UNITED STATES PATENT AND TRADEMARK OFFICE

Office Action Summary

10/524,811

DETAILED ACTION

FIG. 1

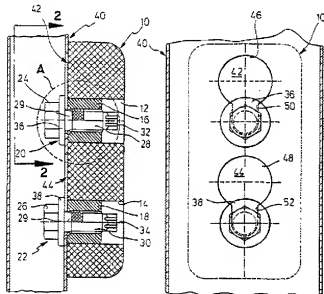
Re claim 13: Self-locking bolt is taught in Column 3 lines 17-23 as a coated thread (60).

shank is partially provided with a plastic coating 60 which allows the fastener 20 to remain in the pre-assembled 20 position. The coating 60 not only secures the pre-assembled state, but also locks the screw when finally tightened as shown in FIG. 1.

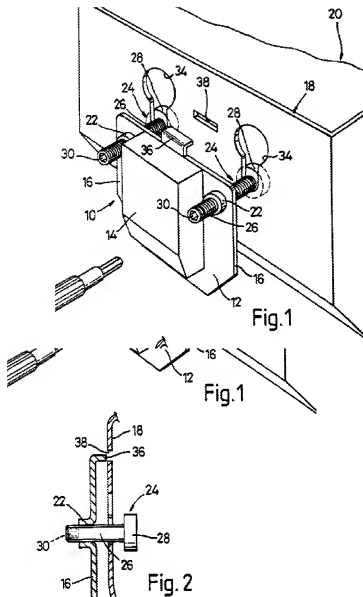
Re claim 17: The fasteners are described as threaded shanks in Column 2:

Threaded fasteners 20, 22 are provided with a head 24, 26, threaded shanks 28, 30 and ends 32, 34. The threaded shank 28, 30 are threaded into the inner threads of the inserts 16, 18. The ends 32, 34 of the shanks 28, 30 each have a Torx-portion. The heads 24, 26 have integrally formed radial flanges 36, 38. A non-threaded portion 29 joins the heads 24, 26.
